# CI 104 Maintenance – Vpse clarification and MDI faults

G. Zimmerman/ADI, APL Group, Cisco,  
CommScope, Marvell, SenTekSe

6/15/2021

Figure 104-3—PoDL system block diagram

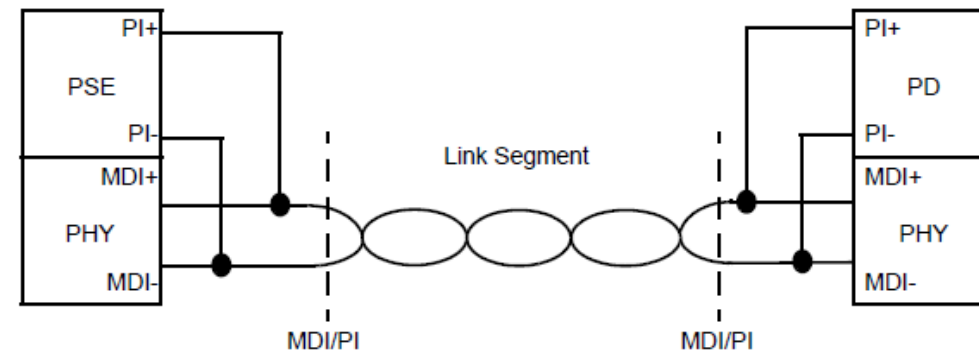
# Issue: Vpse & Vpd are each across the pair

We assume it but don't say it.... IEEE 802.3bt eliminated the definitions in 1.4 for VPSE and VPD, and put them in clause 145 in a similar section to 104.3 where there is a table similar to Tables 104-1 & 1a in 104.3.

- The proposed text is in the PoE clauses, but absent in Clause 104
- This issue has caused confusion with the IEEE PES Surge Protection folks, thinking it could be conductor to shield, allowing > 60V across the pair

- We show it, but don't say it in text:

Proposed Change: Insert the following 2 new paragraphs after the last sentence in 104.3:

VPSE is the voltage at the PSE PI. VPSE is measured between any positive conductor and any negative conductor at the PI.

VPD is the voltage at the PD PI. VPSE is measured between any positive conductor and any negative conductor at the PI.
